Issue 26: Neuchatel changes part 2

The Neuchatel group have finished their proposal regarding classification index and classification index entry object. Here is their final picture:

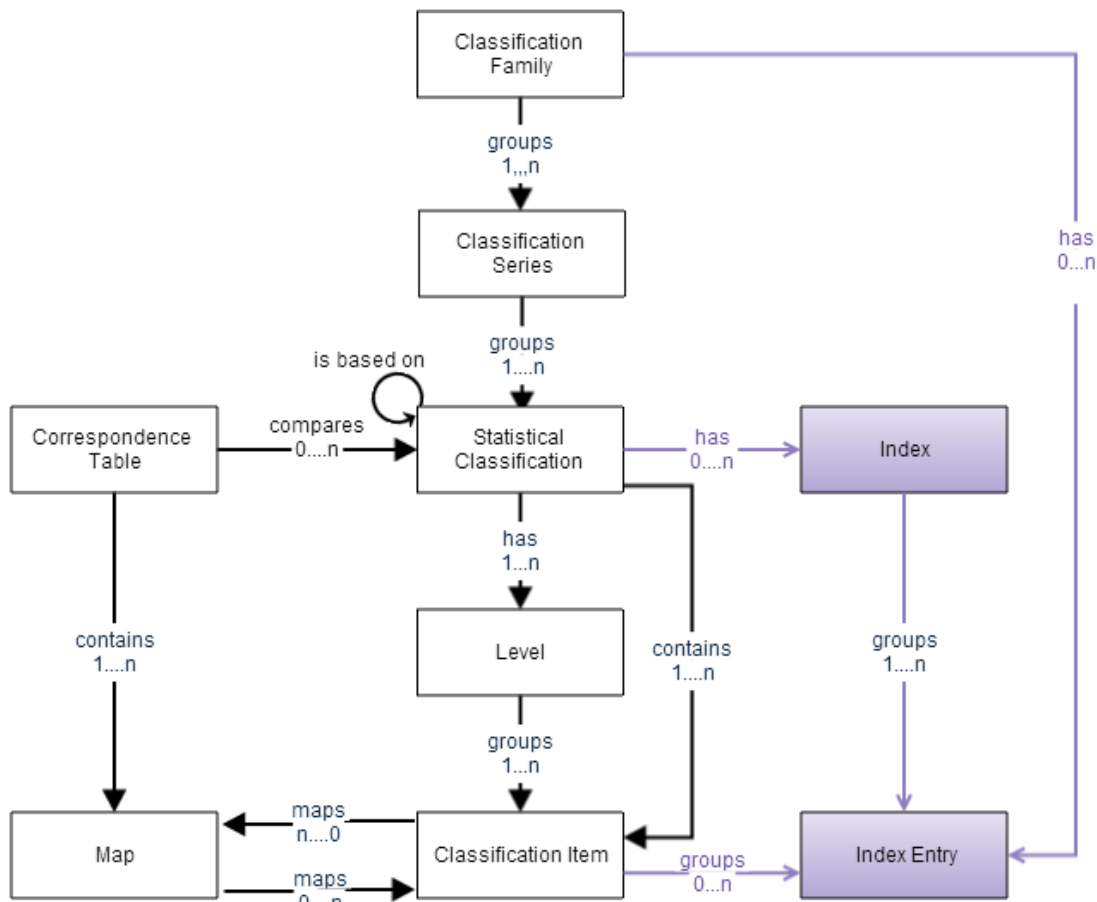
This proposal adds two objects to GSIM and closely mirrors the original Neuchatel model

These objects could be added to the model as Classification Index/Index Entry or as Index/Index Entry. The question is could these objects be broadened out?

If they are only for classifications, should indexes be in this level of GSIM? Do they only belong in the Neuchatel annex?
